OPERATION SAFETY NOTICE

AA-23011
28 November 2023

SUBJECT: Expandable Pins Assembly in Tail Rotor Pedal Lockout Kit, P/N 206-928-110 a subassembly of P/N 206-928-200.

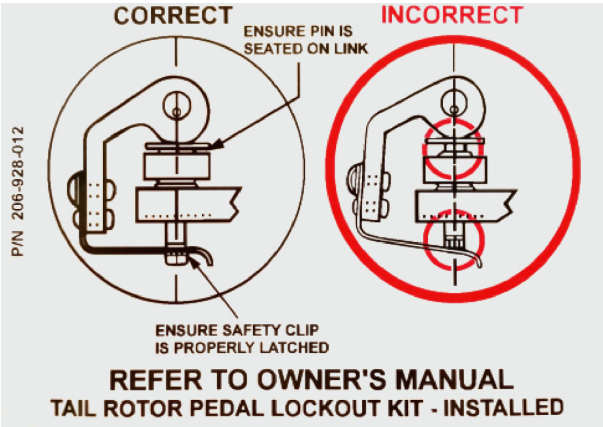
Operators have reported experiencing a shearing, fracture, or failure of Expandable Pins/Bolts within the threaded portion of the pin. This condition results from improper installation of the expandable pin. Proper installation/inspection must be completed as follows:

PERFORM DAILY/PREFLIGHT VISUAL INSPECTION

Reference Section 4.0, Maintenance Instructions, 4.1.1, Tail Rotor Pedals Locked Out, in the Instructions for Continued Airworthiness Report No. AA-99032 to perform the required Daily/Preflight Inspection. If adjustments are found to be necessary, refer to Section 4.5 of Instructions for Continued Airworthiness, Report No. AA-99032.
